TO: ALL BIDDERS	FROM: Luis Ponce, P.E.
COMPANY:	DATE: 9/26/11
FAX NUMBER:	TOTAL NO. OF PAGES INCLUDING COVER:
PHONE NUMBER:	SENDER'S PHONE NUMBER: (360) 354-3687
RE: City of Ferndale Addendum 2	SENDER'S FAX NUMBER: (360) 354-0407

ADDENDUM NO. 2
To the Contract Provisions for
City of Ferndale, Washington

**EATON, SOMERSET, WILLARD, AND WASHINGTON SEWER
PROJECT NO. SS2011-01**

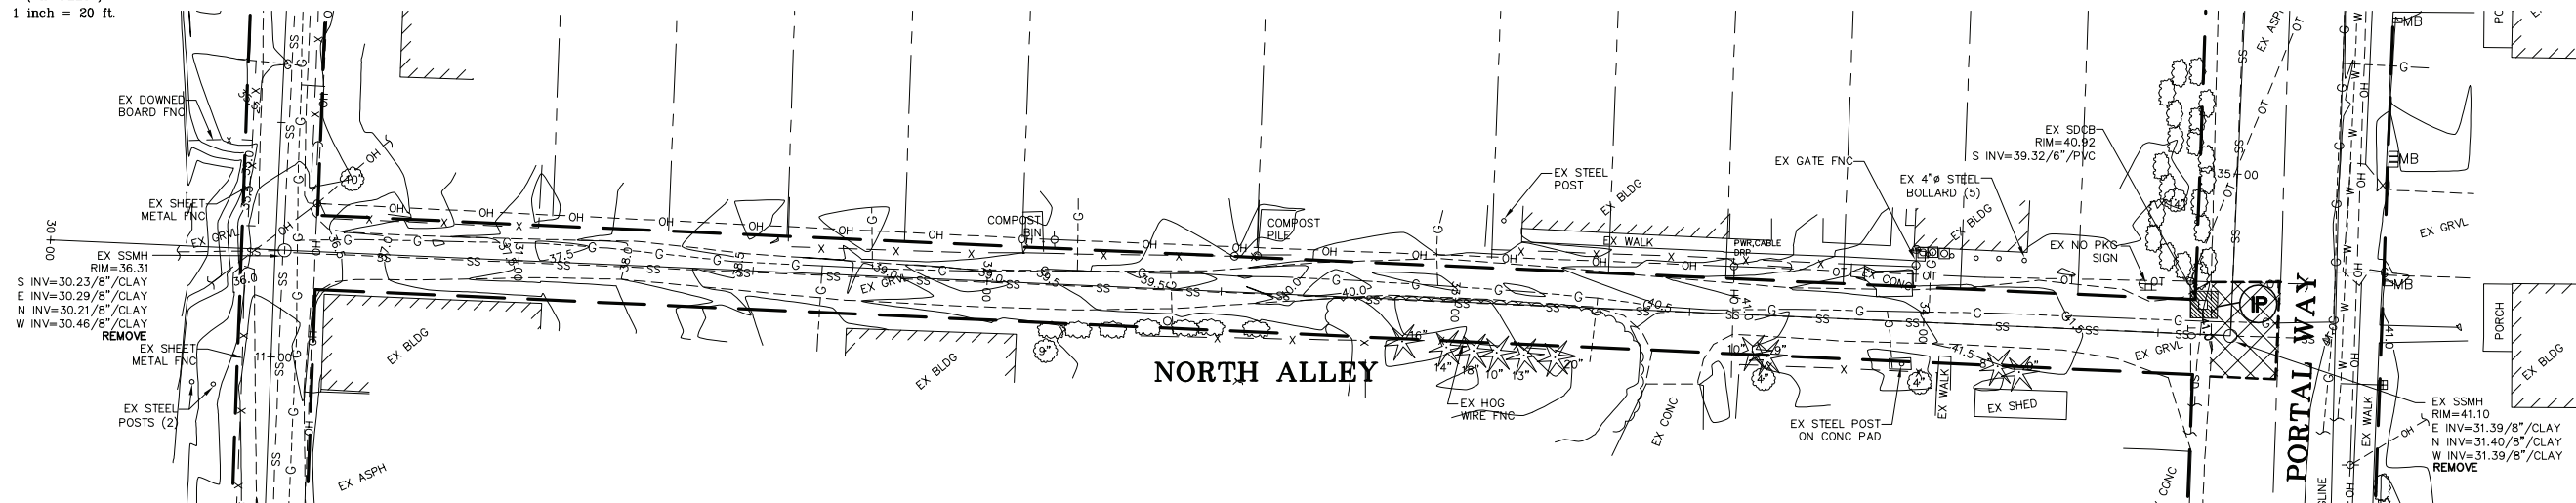
The horizontal limits shall also be measured in accordance with the attached "Typical Trench Section STA 3+00 to 12+75" detail sheet.

5 of 12

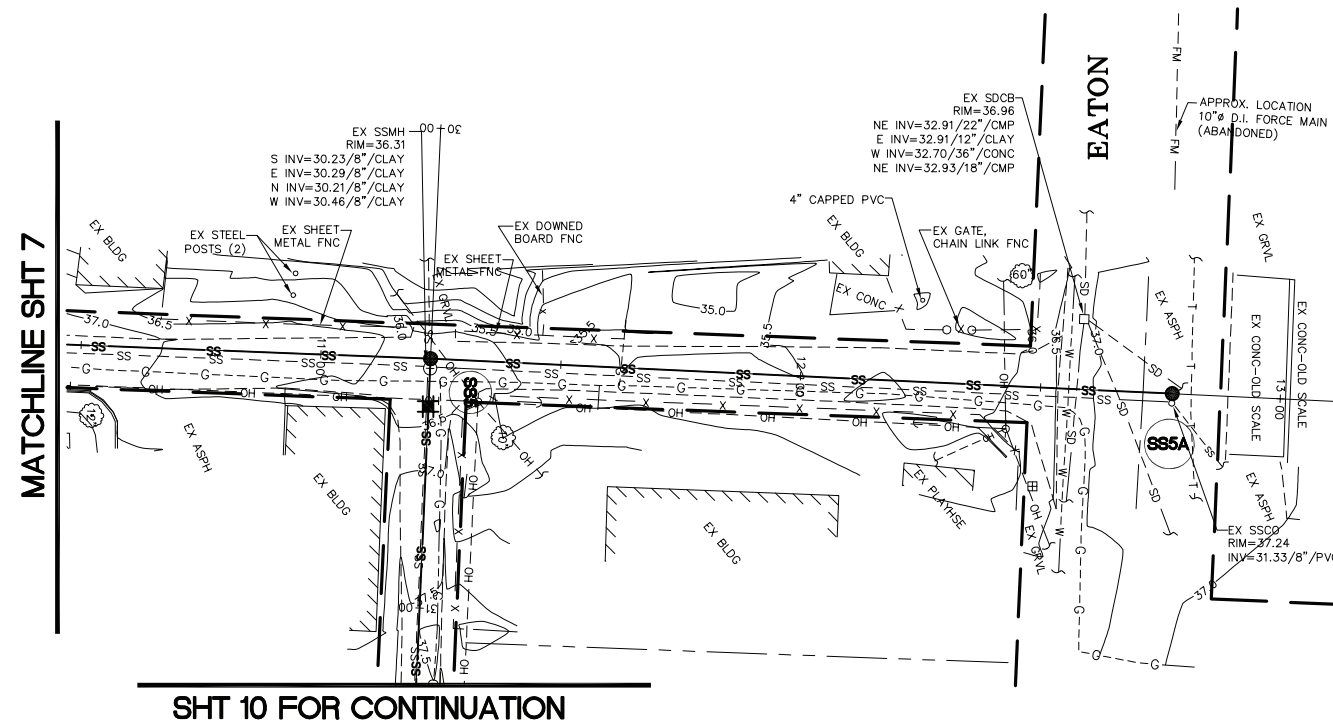
The proposed sanitary sewer alignment between STA 3+00 to STA 12+79 has been shifted 2' west. The attached Plan Sheets reflect this revision. The attached Plan Sheets shall replace Addendum No. 1 Plan Sheets.

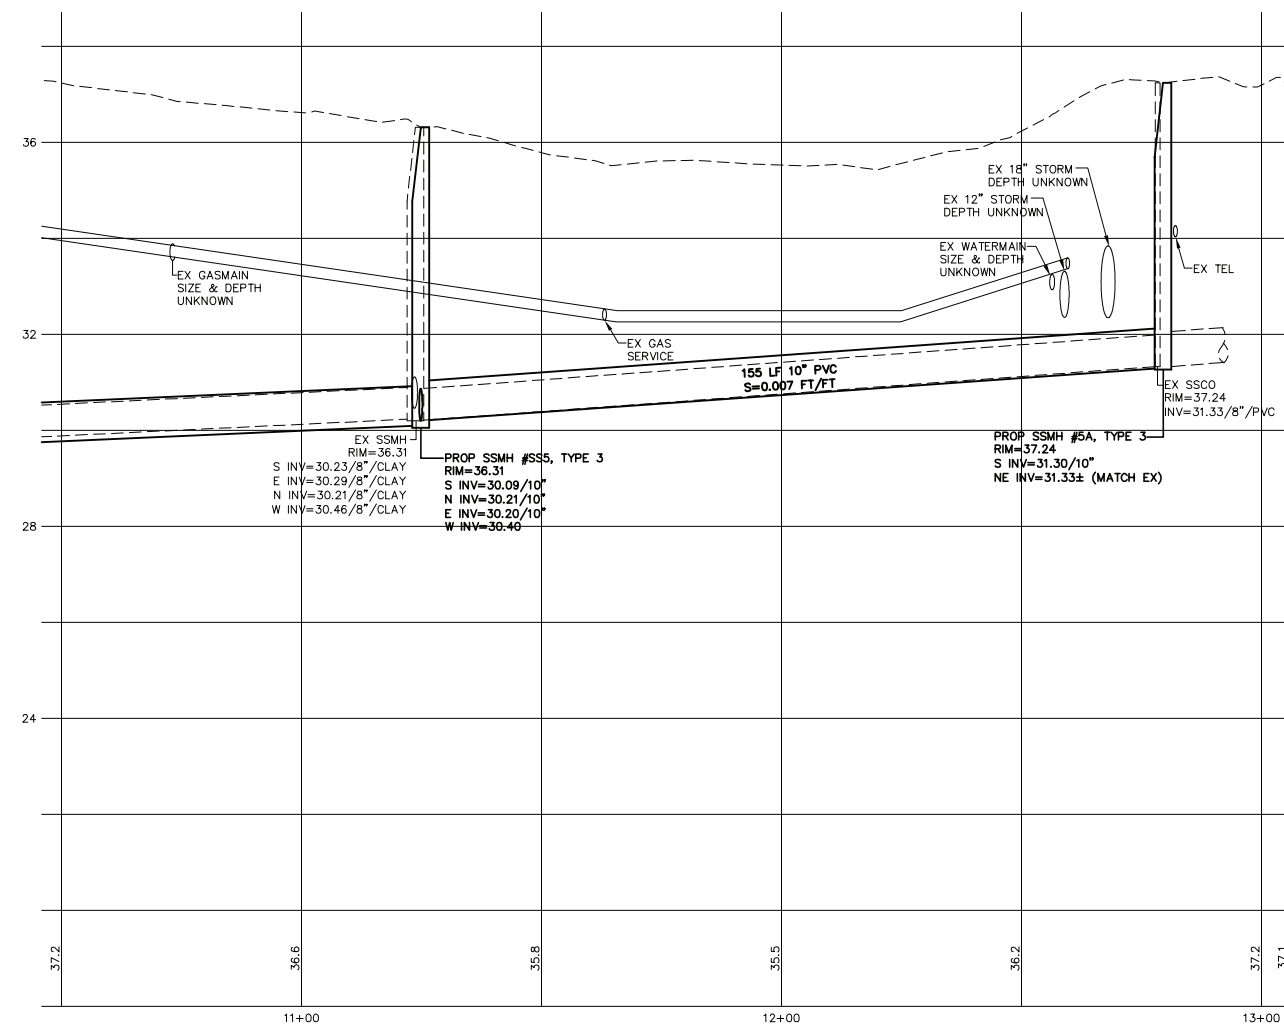
NOTE: UNLESS NOTED, SIDE SEWER LOCATIONS UNKNOWN. CONTRACTOR TO DETERMINE SIDE SEWER LOCATIONS AS THE NEW MAIN IS INSTALLED. FOR BASE BID, NEW SIDE SEWERS SHALL BE INSTALLED FROM NEW MAIN TO RIGHT OF WAY.

DATE
9-26-11
SHEET
10 of 12

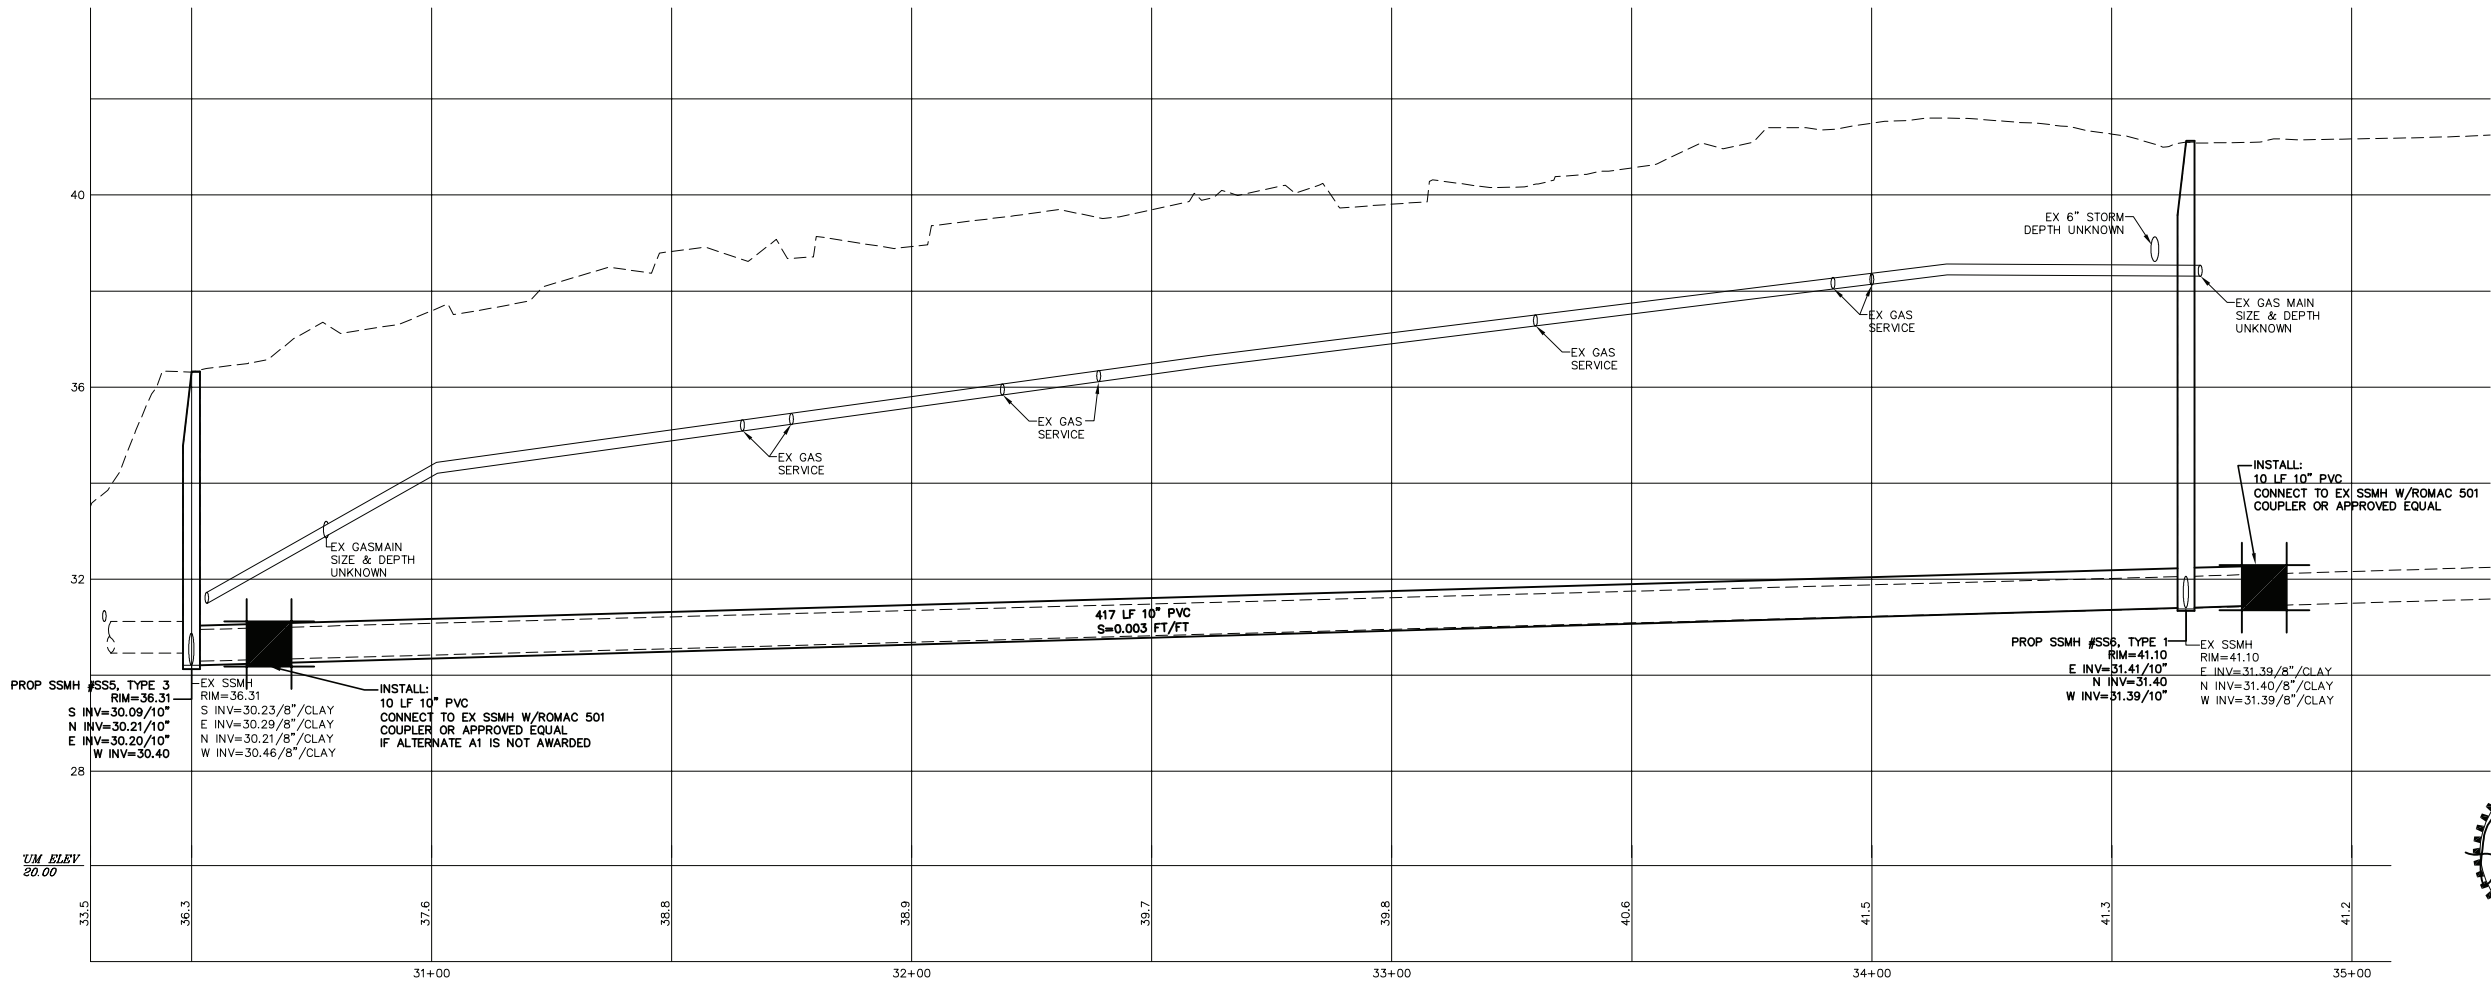
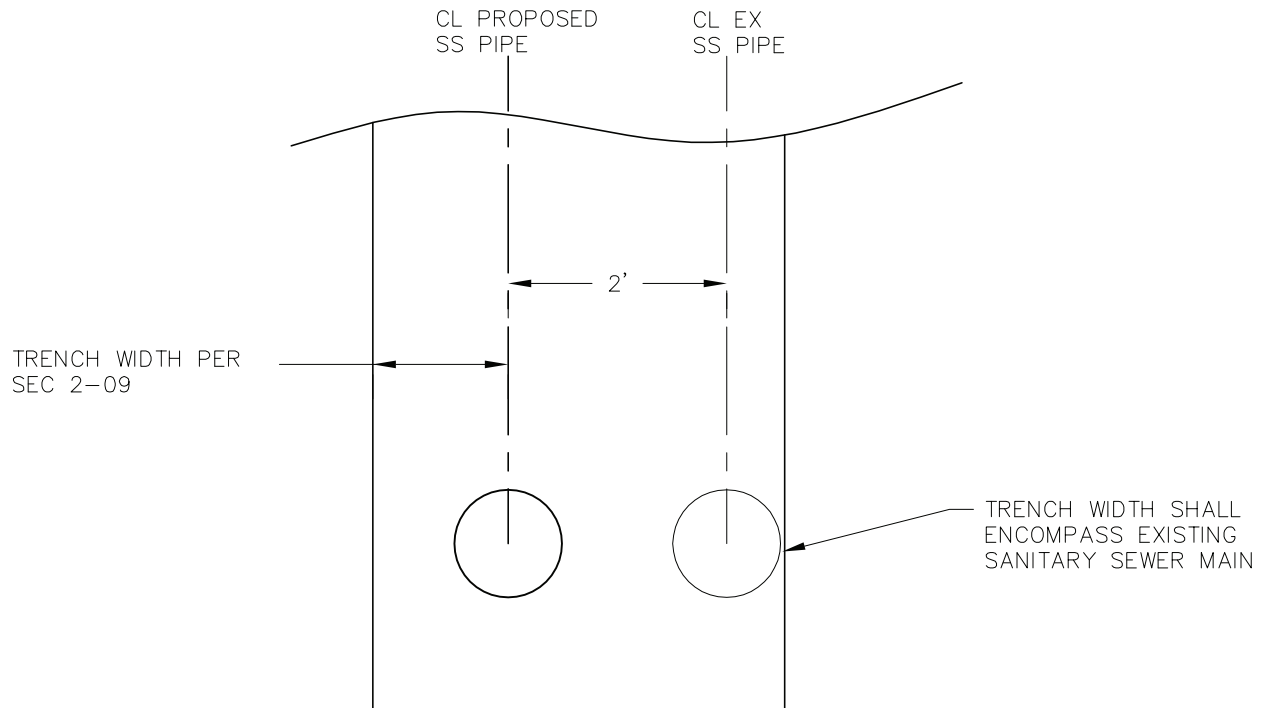
NOTE: SIDE SEWER LOCATIONS UNKNOWN.
CONTRACTOR TO DETERMINE SIDE SEWER LOCATIONS AS
THE NEW MAIN IS INSTALLED. BETWEEN STA 30+50 TO
STA 34+75, SIDE SEWERS SHALL BE INSTALLED FROM
THE NEW MAIN TO THE RIGHT OF WAY.
